### HISTORIC DISTRICT COMMISSION

Regular meeting

6:30 p.m. September 3, 2025

- A. Certificate of Appropriateness Application: **311 W. Orange St.** - New construction house (PIN 9864883297)

**RIGHT ELEVATION**  
Scale: 1/4" = 1'-0"

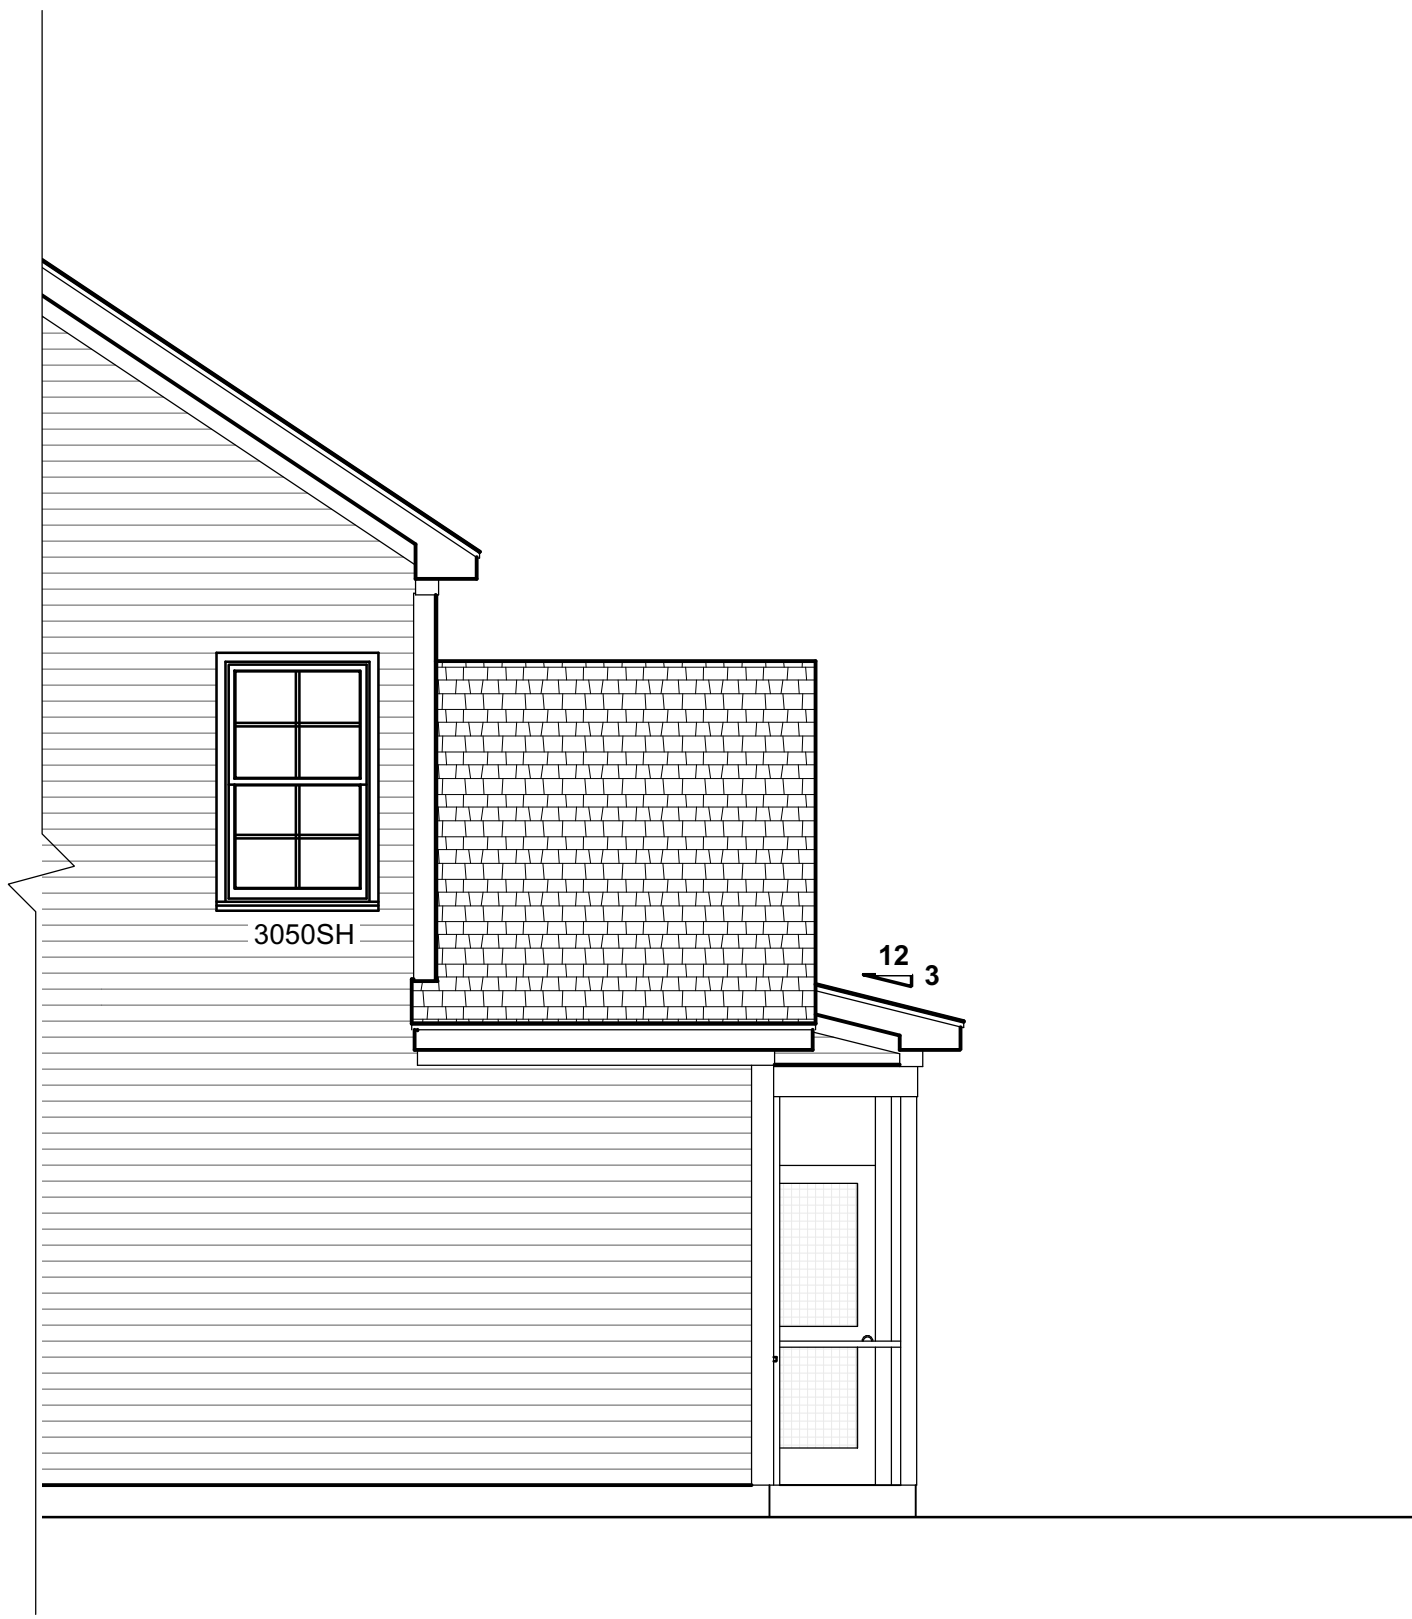
It was observed that the plans are missing a materials listing for the garage door. There were questions about the intent of the screened porch being marked as "optional."

The commissioners said they would like to see as much supporting evidence as possible to show that this architectural style and design is congruent with the district. They also said that they would like to see how these plans are congruent without trying to imitate a home of an earlier era. The commissioners had concerns about the curve and pitch of the roof. They said they would like to see clear thought and strategy for how the house and driveway could be sited to minimize disruption to the site in terms of trees and grading.
